P&Z CASE # SP2021-025 P&Z DATE 10/12/21 CC DATE _____ APPROVED/DENIED _____
ARCHITECTURAL REVIEW BOARD DATE _____ HPAB DATE _____ PARK BOARD DATE _____

PROJECT NUMBER: SP2021-025
PROJECT NAME: Site Plan for St. Benedict Church
SITE ADDRESS/LOCATIONS: 1500 SUNSET HILL DR, ROCKWALL, 75087

09/22/2021: SP2021-025; Site Plan for St. Benedict's Church

TO: Planning and Zoning Commission
DATE: October 12, 2021
APPLICANT: Dub Douphrate; *Douphrate & Associates*
CASE NUMBER: SP2021-025; *Site Plan for St. Benedict's Anglican Church*

SITE PLAN
ST. BENEDICT'S ANGLICAN CHURCH PROPERTY
1500 SUNSET HILL DR
CITY OF ROCKWALL
ROCKWALL COUNTY, TEXAS

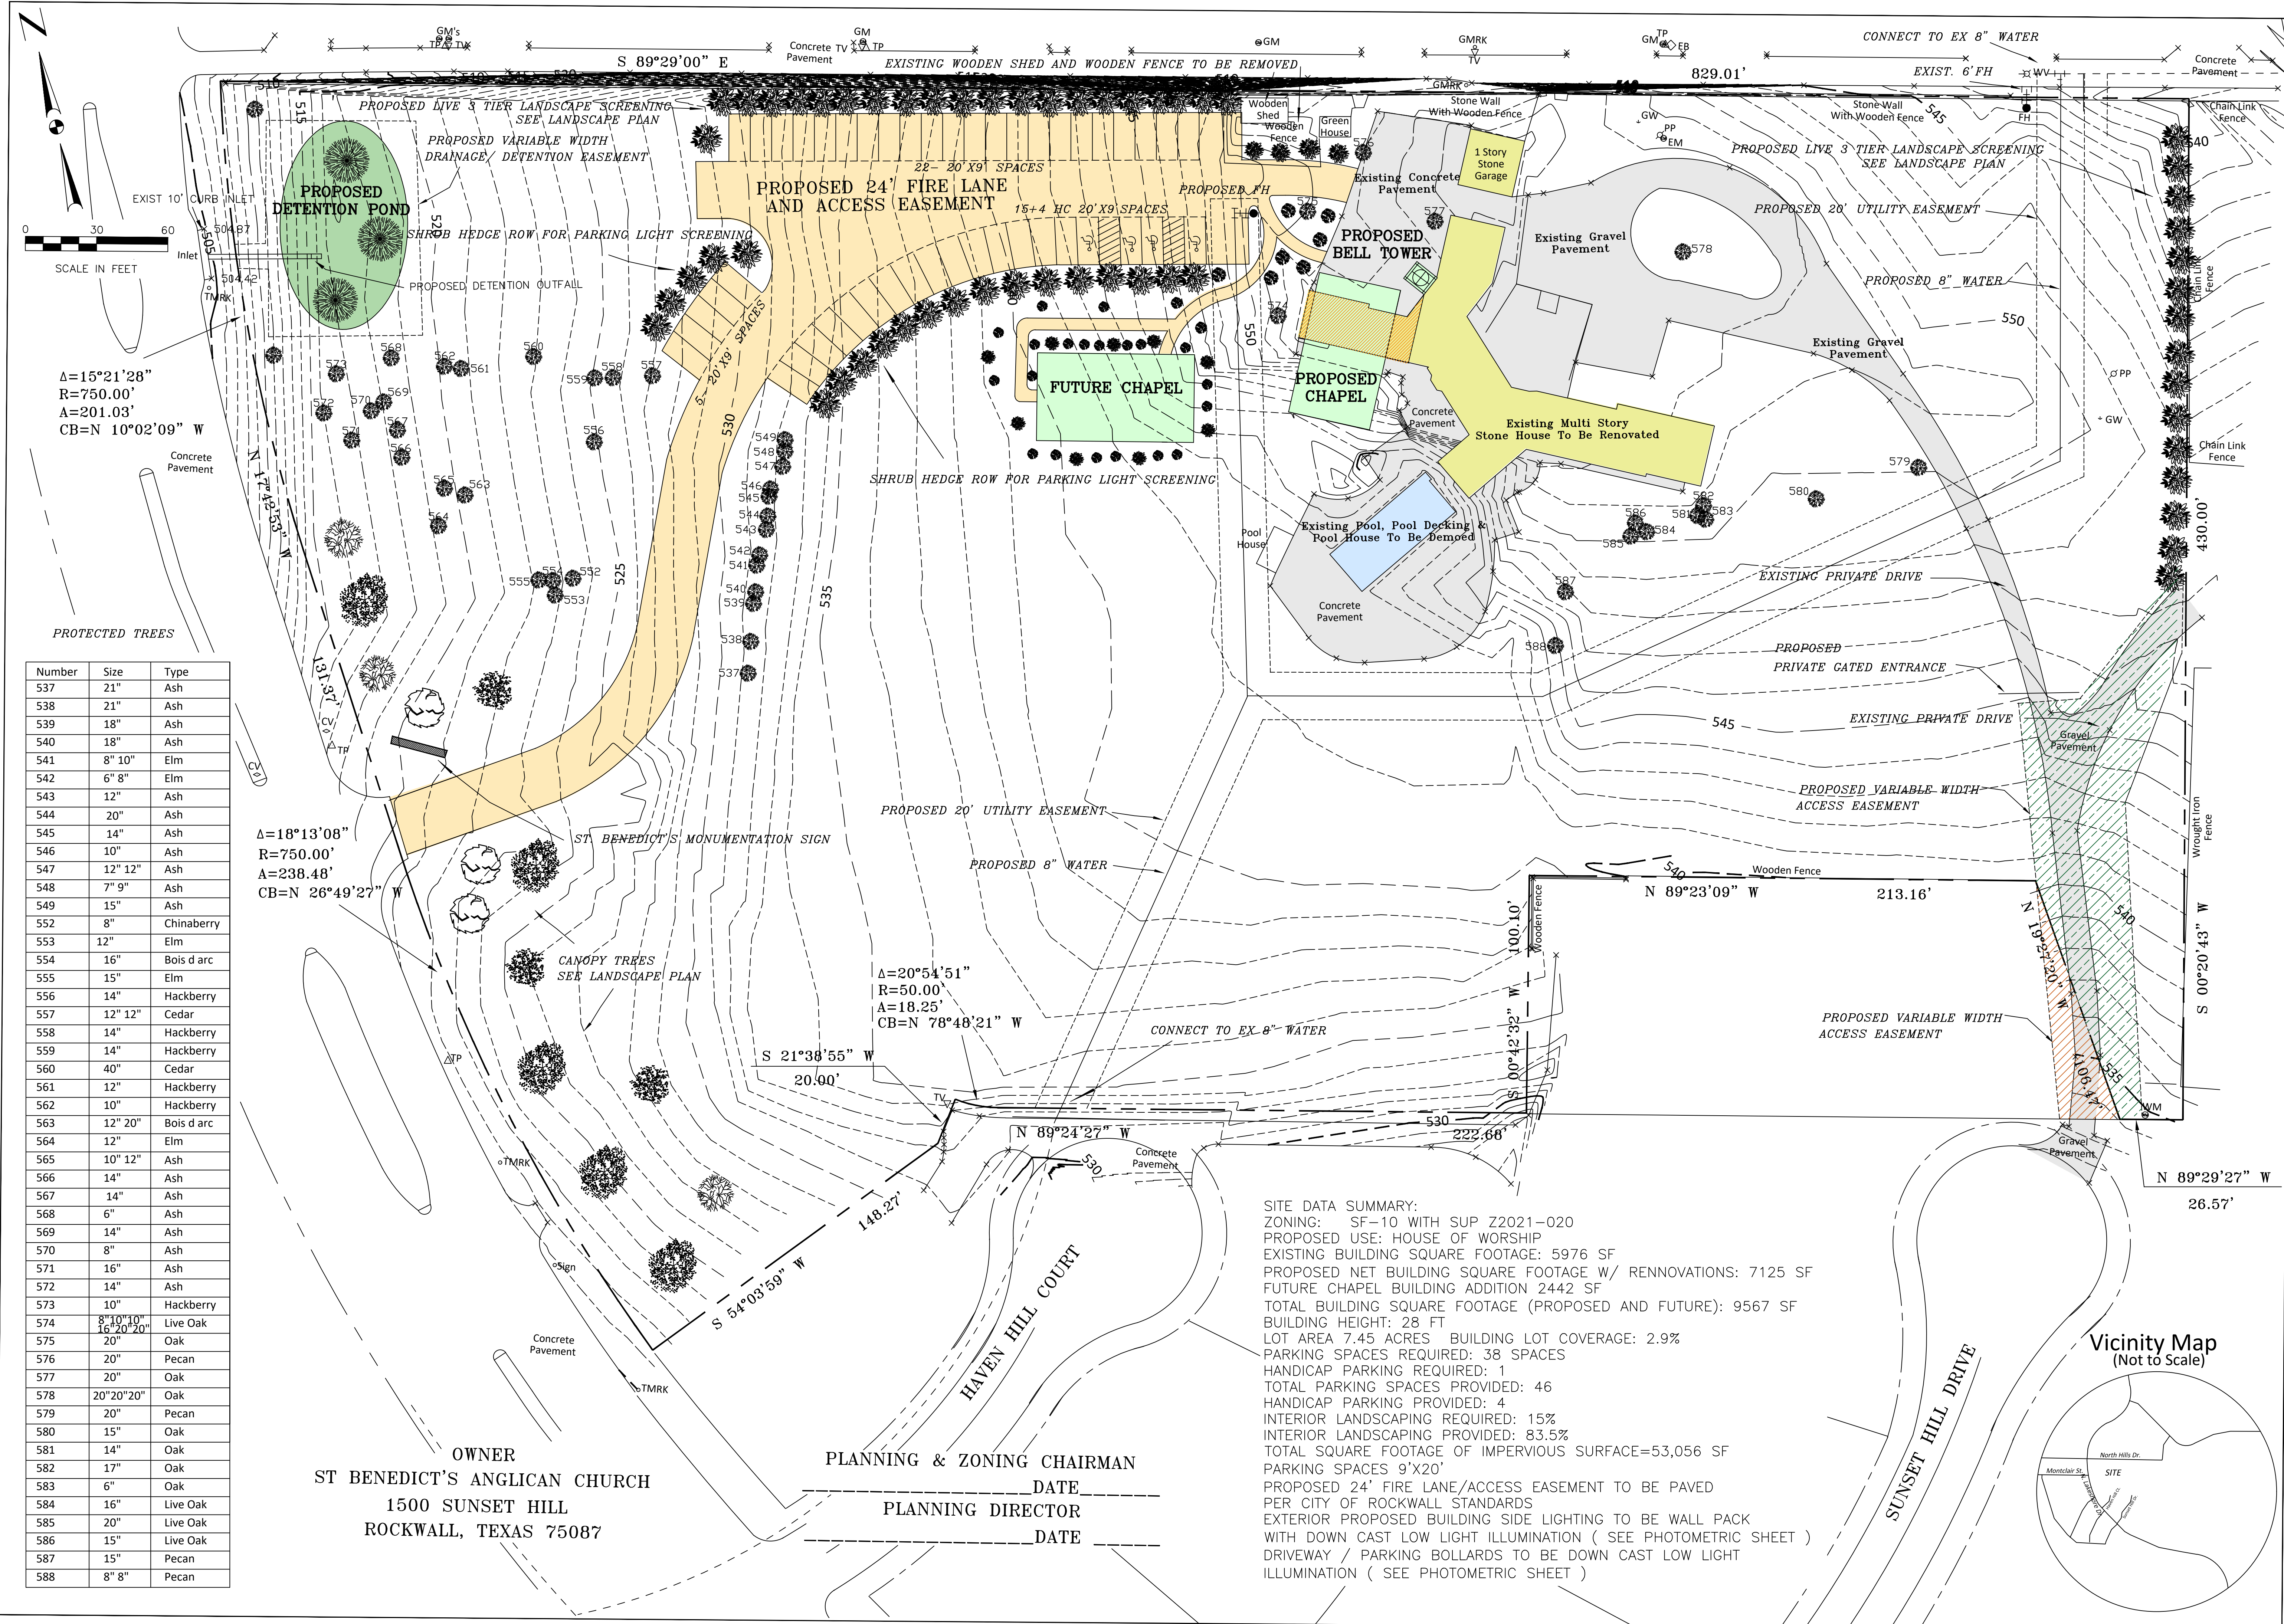
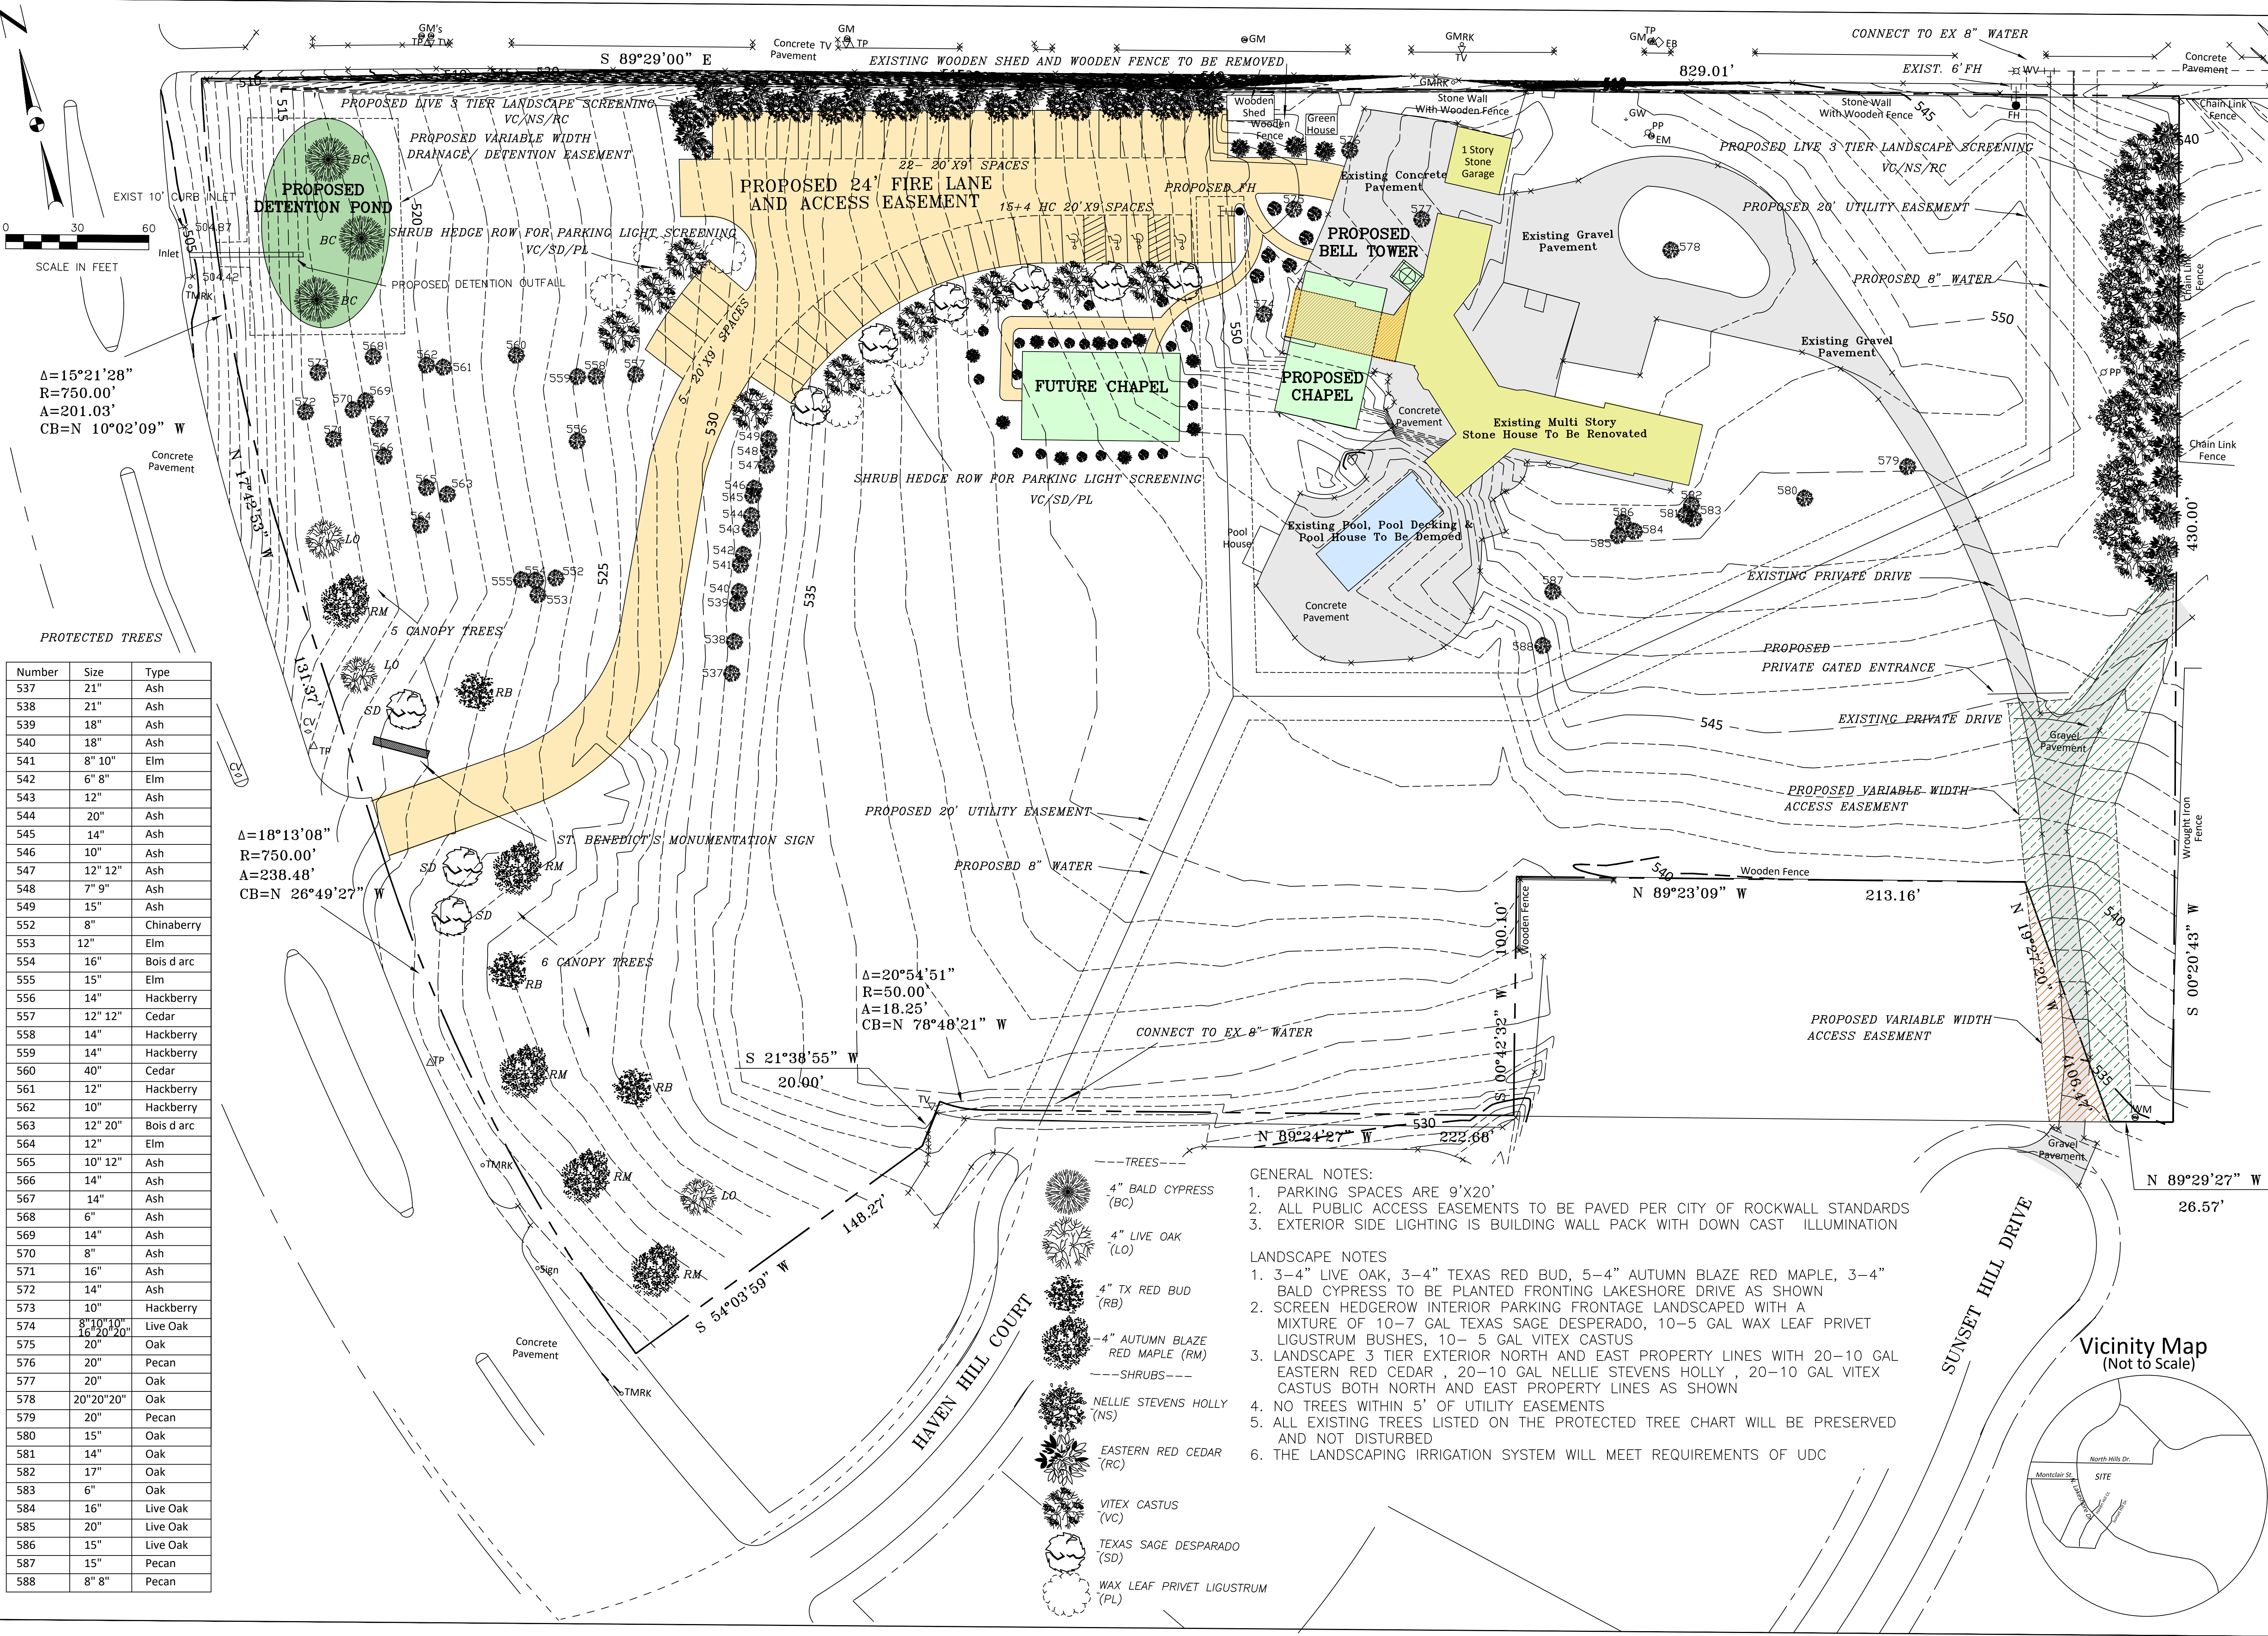
I.7 Drop the contours from the site plan to increase legibility as well as allow for the required information to be added.

M.8 Site Plan:

1. Provide the square footage of the subject property. (Subsection 03.04.B, of Article 11)
2. Indicate all building setbacks adjacent to right-of-way. (Subsection 03.04.B, of Article 11)
3. Indicate all easements existing and proposed. (Subsection 03.04.B, of Article 11)
4. Indicate all drive widths and drive radii. (Subsection 03.04.B, of Article 11)
5. Indicate the adjacent street right-of-way, street names, and street centerlines. (Subsection 03.04.B, of Article 11)

6. Provide a parking table. (Subsection 05.01, of Article 06)
7. Indicate if adequate parking has been provided. Parking for a House of Worship is 1 per 4 seats; the number of seats in the chapel has not been indicated. (Table 5, of Article 06)

8. Signage will be covered at building permit and is not approved via the proposed site plan. (Subsection 06.02, F. of Article 05)
9. Indicate any pad mounted or roof mounted utility equipment and their subsequent screening. (Subsection 01.05, C. of Article 05)

10. Indicate if there is a dumpster on site or if one is to be constructed. If one is to be added to the site it must be indicated; this must include the mandatory screening as well. (Subsection 01.05, B. of Article 05)

11. Residential Adjacency: Per the Specific Use Permit (S-250) 3-tiered landscaping will be required as depicted in the Concept Plan in S-250 (along the north property line from in front of the parking to near the north-east property corner, and from the north-east property corner south to the existing drive). (Subsection 01.06, of Article 05; S-250)
